2016 Amendments to Chapter 14 Subdivision Regulations

Article 14-1 Title, Authority and Definitions

Figure No 6 - Parkway Road Section

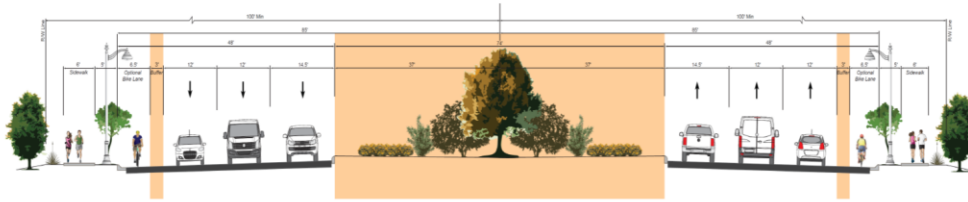
33. Sec. 14-6-8: Added Figure 6-17.

ROW Width	Median Required	Median Width	Curb Type	# of Travel Lanes	On-Street Parking Required	Bike Lane Required	Sidewalk	Landscape Strip
200'	Yes	74'	Inside vertical curb, outside vertical curb and gutter	3 travel lanes each side, plus turning lane	No	Yes	Detached	5' wide at B.O.C.

Figure No 16 - Local Road Section (option 3)

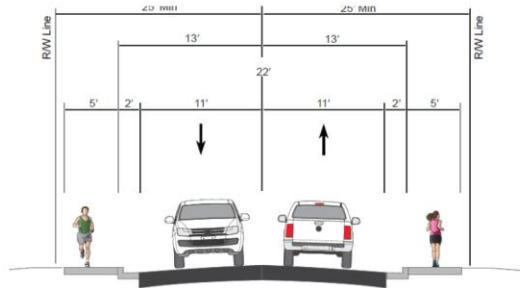
ROW Width	Median Required	Median Width	Curb Type	# of Travel Lanes	On-Street Parking Required	Bike Lane Required	Sidewalk	Landscape Strip
50'	No	n/a	Outside rolled curb and gutter (*)(***)	1 travel lane each side	No	No	Attached (***)	3'6" wide at B.O.W.

Figure No 17 - Industrial/Commercial Local

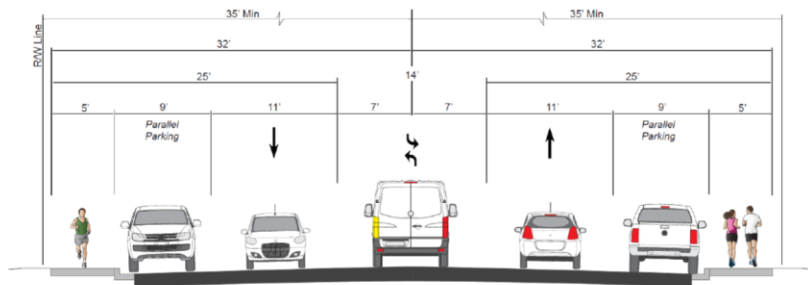
ROW Width	Median Required	Median Width	Curb Type	# of Travel Lanes	On-Street Parking Required	Bike Lane Required	Sidewalk	Landscape Strip
70'	No	n/a	Outside vertical curb and gutter	1 travel lane each side, with two way left turn	Yes	No	Attached	5' wide at B.O.W.
